# City of Raleigh

## COA-0012-2019

412 N EAST STREET  
OAKWOOD HISTORIC  
DISTRICT (R-10)

## APPLICATION FOR A CERTIFICATE OF APPROPRIATENESS – STAFF REPORT

## Detail on proposed parking plan as it relates to NC DOT guidance on angled parking

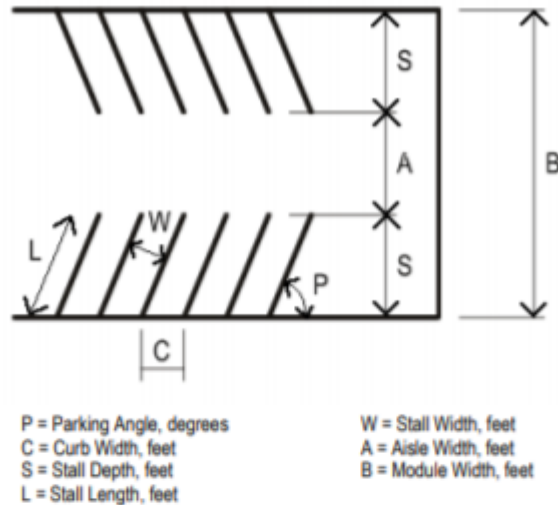
- 16\* Applicant testimony at the May 23<sup>rd</sup> COA hearing noted that parking at a 90-degree angle is not possible due to the width of the alley. The applicant is proposing an angled parking pad. Documentation was provided to show that the proposed parking pad could not accommodate more than two vehicles.

With only 112 feet of Aisle Width in our alley, 90 degree parking is not possible (only 0, 30, or 45 is possible. The proposed parking pad is designed to accommodate angled parking for 2 “regular” cars.

Detail on proposed parking pad showing dimensions (including alley) as they relate to NC DOT guidance on angled parking (note, with cars superimposed)

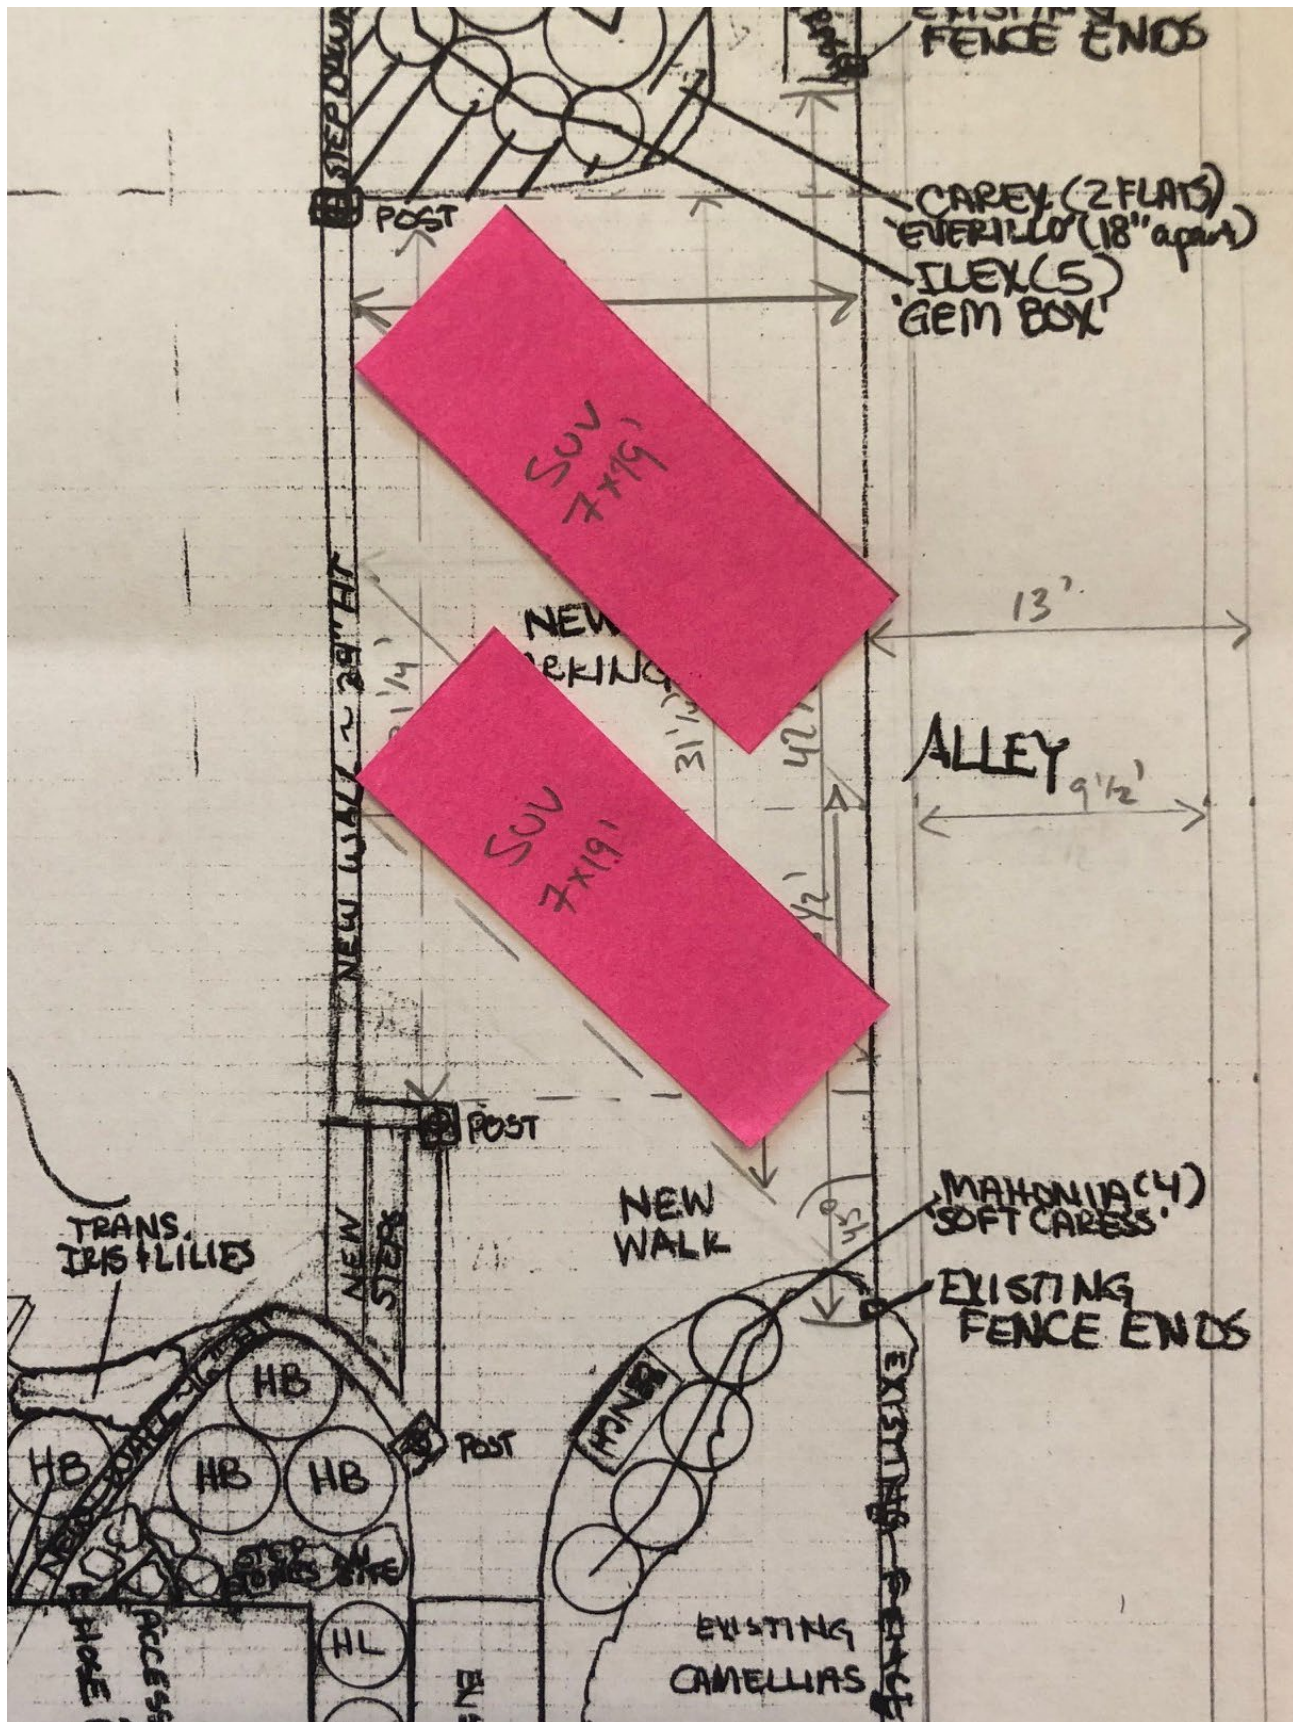
- **Show cars on the proposed plan** - page 9 - in the graphic with "pink rectangles" - we used "standard SUV dimensions"
- **Provide existing and proposed landscape plans** - pages 2-6 - existing survey and plot plan included along with simplified proposed landscape plan (removed bird feeders, furniture, etc.) - detailed landscape plan provided as separate PDF

# 412 N EAST ST - PROPOSED GRADING WALL

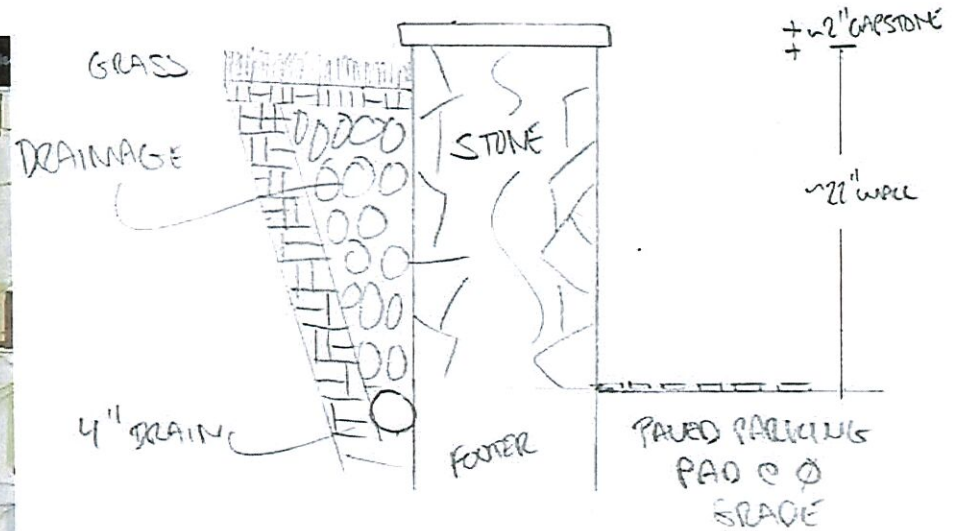
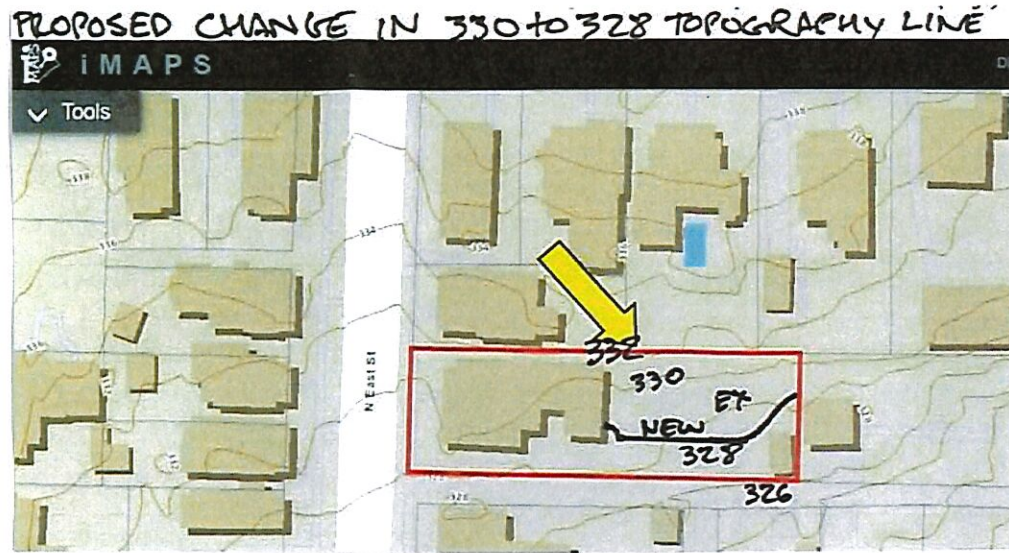
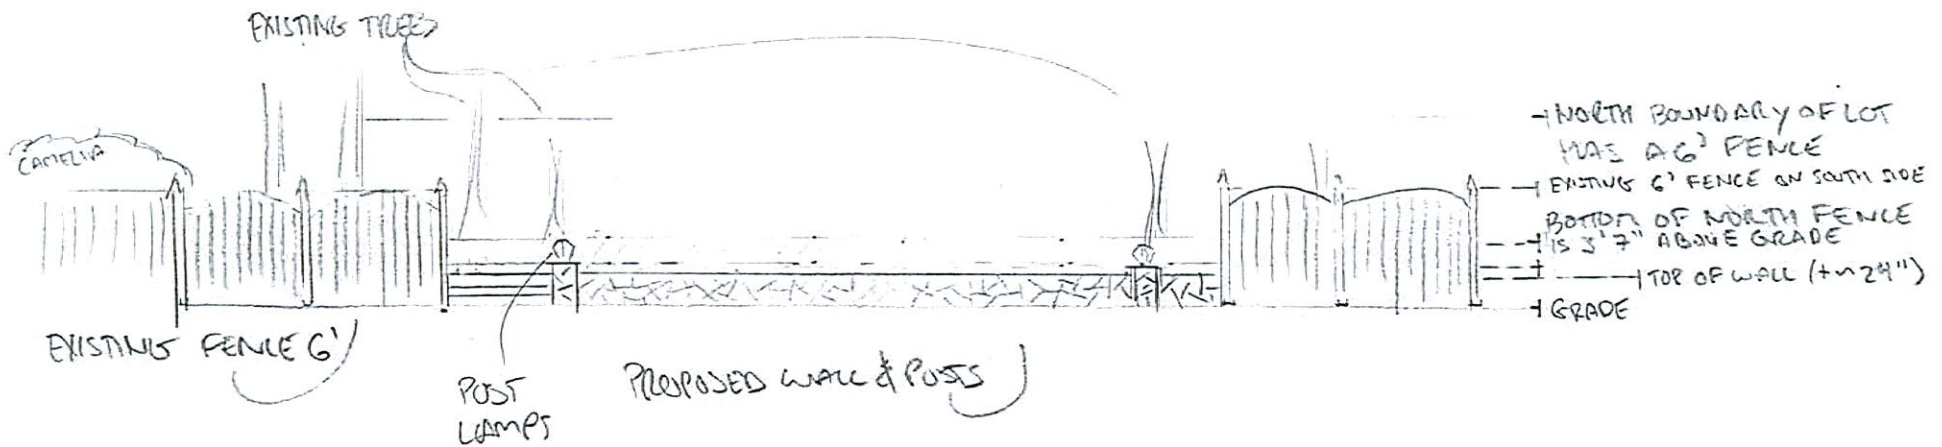
- 9\* A 2' tall fieldstone retaining wall with low hedges is proposed to facilitate the re-grading and allow for the installation of the parking area. An elevation and section were provided.

- 11\* A photo was provided on page 16 that indicated the stone columns along the retaining wall would be topped with lamps that match the exterior lighting on the front porch. This style of lamp/wall post combination is atypical to Oakwood.

1. That there be no delay for the removal of the two trees;
2. That the retaining wall not have lighting on top of the piers.

# 412 N. EAST ST. - PROPOSED EAST DECK & ELEVATION

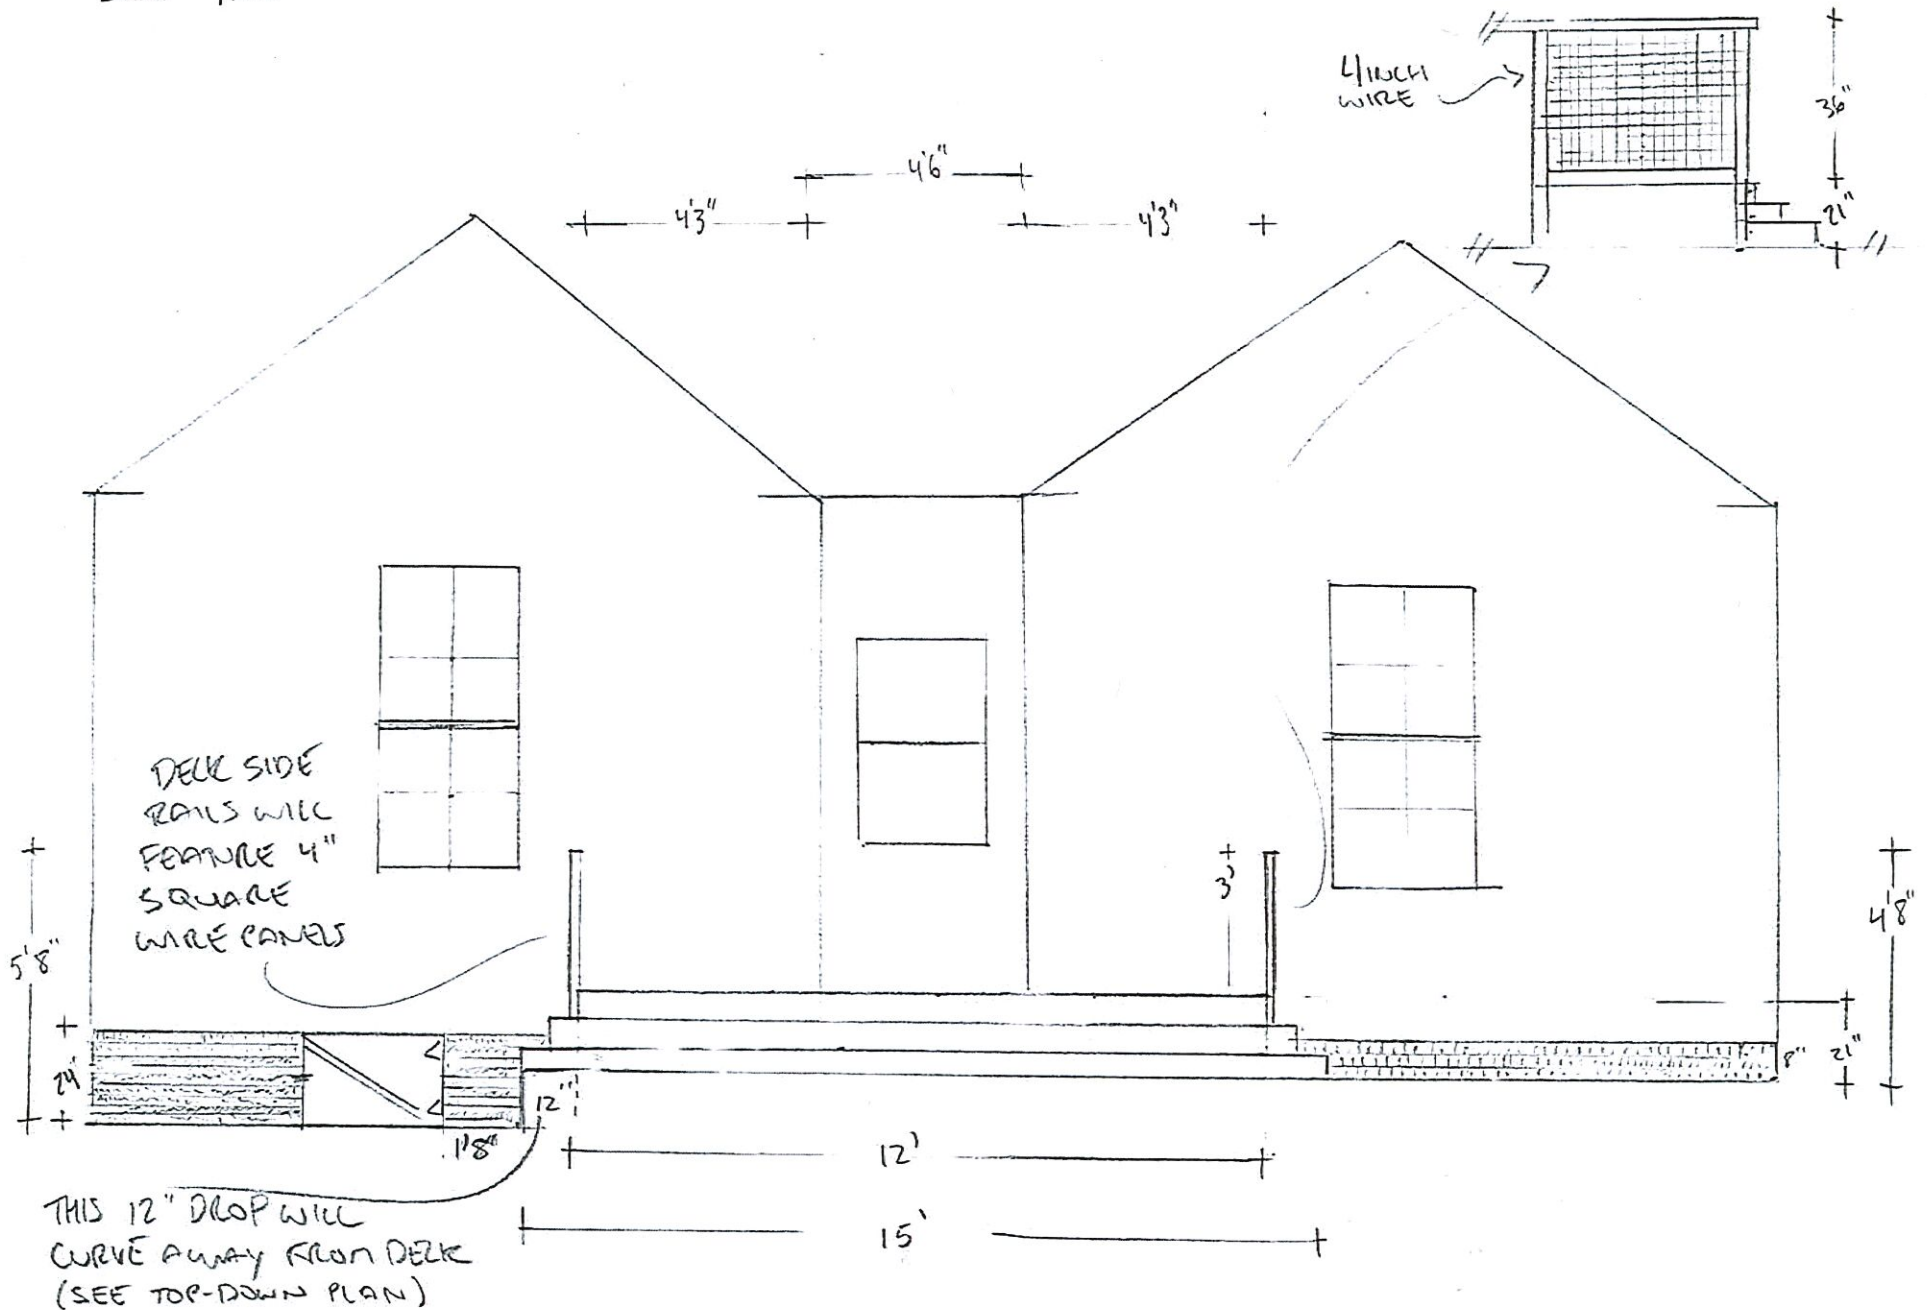
- 17\* As part of the parking pad installation, the 6' fence located around the existing parking area is proposed to be removed.
- 18\* A deck is proposed for the rear (east) façade. The height of the decking is 21" from grade on the north side of the deck and 33" from the south.

- 19\* The railings proposed on the north and south sides of the deck are 4" wire mesh. This railing style is atypical to Oakwood but was historically seen in rear yard fencing. Horizontal wire railings have been found to meet the Design Guidelines on rear decks.
